UNITED STATES PATENT AND TRADEMARK OFFICE

APPLICATION NO.	FILING DATE	FIRST NAMED INVENTOR	ATTORNEY DOCKET NO.	CONFIRMATION NO.
09/971,763	10/09/2001	Moo-youl Kim	P56598	4212

Office Action Summary

DETAILED ACTION

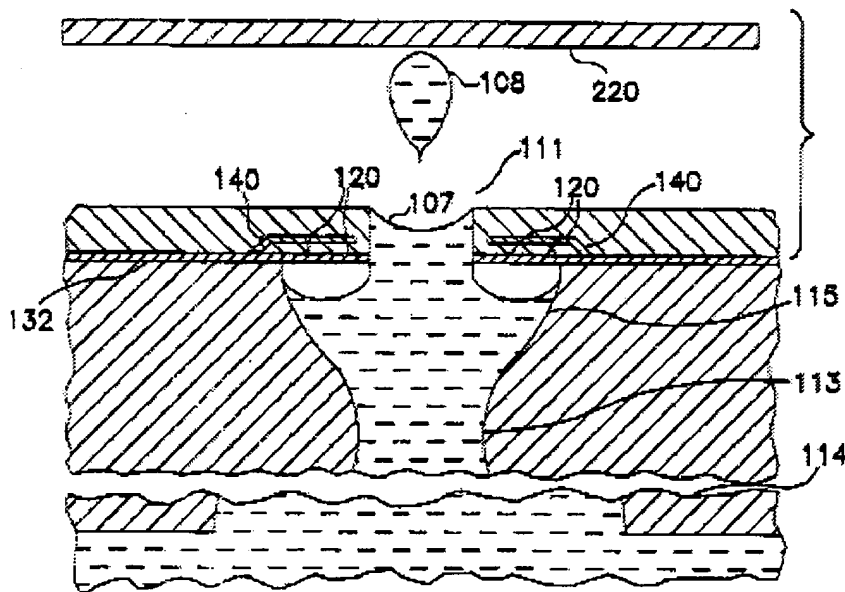
Silverbrook teaches (Fig. 17, above) an ink jet print head comprising a base plate (130), which is perforated by an hour-glass shaped structure having a hemispherical shaped top portion that is filled with ink, a nozzle plate that is mounted on the base plate and is perforated by a plurality of orifices in communication with their respective

chambers, a plurality of dough-nut shaped heaters (120) disposed on the underside of the nozzle plate and surrounding each nozzle and a plurality of ink inlet passages (113), which supply ink from a reservoir to the hemispherical hour-glass shaped chamber. As can be seen Fig. 18 (which is a reverse structure of Fig. 17), each hemispherical chamber is connected to a funnel shaped chamber (489). Since Fig. 18 is a reverse of Fig. 17, these funnel shaped chambers would be found beneath the hemispherical chambers of Fig. 17.
